## Application for Licence Amendment

<b>Licence Number</b>	L7738/2000/9
<b>Licence Holder</b>	Water Corporation
<b>ACN</b>	634 169 841
<b>File Number</b>	DEC1113/1~3
<b>Premises</b>	Margaret River Wastewater Treatment Plant Corner Long and Tare Roads BRAMLEY WA 6285  Legal description – Being Forest Lease 2112/97 and Part of State Forest No. 56 As defined by the Premises map in Schedule 1 of the Revised Licence
<b>Date of Report</b>	16 March 2026
<b>Decision</b>	Revised licence granted

Figure 2: Monitoring network

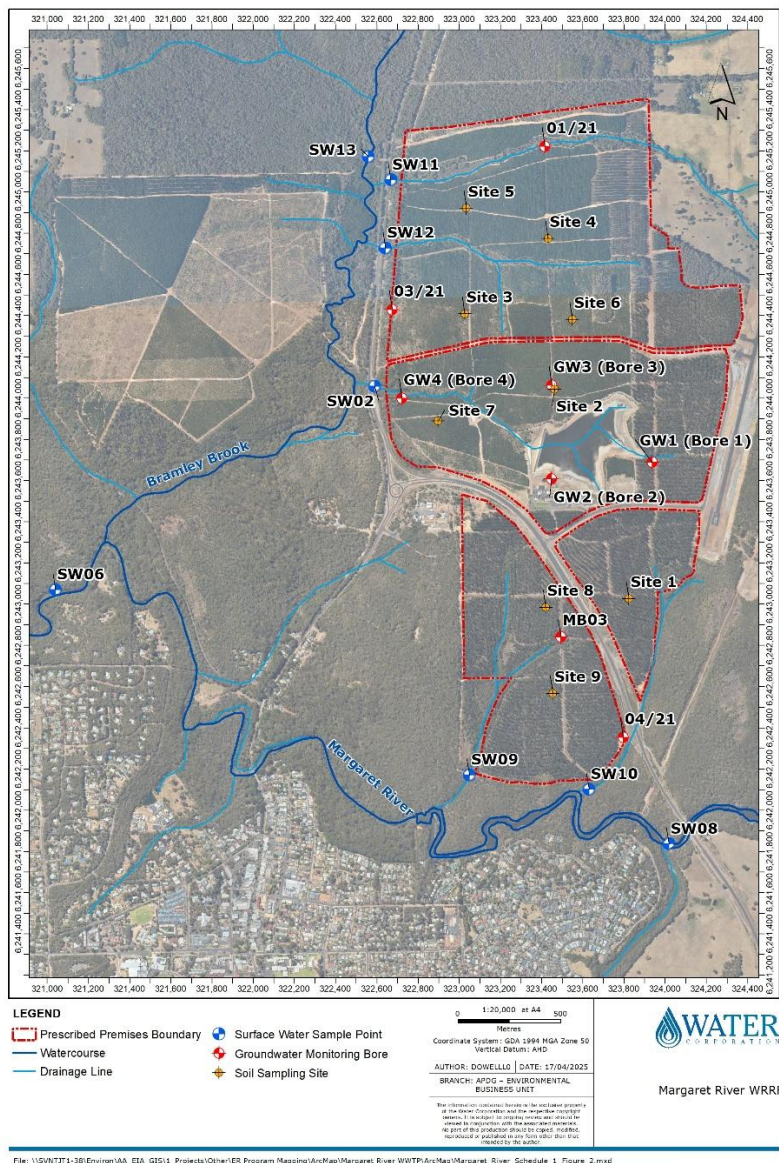
Condition	Summary of Licence Holder's comment	Department's response
Front Page	Date of issue in current licence states 24/10/2014. Date of issue in draft licence states 01/11/2013. Please change to correct date	Issue date on the existing licence is incorrect. Issue date of 01/11/2013 provided on the draft licence is correct. No change made.
2, Table 2	Remove belt press since it is no longer part of the process	Noted and updated
2, Table 2 and 3	Re-use water is also used for irrigation at the garden area at the WRRF. Update	Noted and updated
6	Change wording of "licensed landfill facility" to "licensed facility". Other disposal opportunities may arise in future (waste to energy for example)	Noted and updated
12, Table 3, Note 1	Soil sampling is measured in mg/kg. Add soil sampling to the exceptions	Noted and updated
19, Table 4	Amend bores to reflect proposed new program.	Noted and updated
Figure 2	Update Figure 2 with new Figure provided	Updated

N/A	Updated Figure 2 - Map of groundwater, surface water and soil sampling site monitoring locations
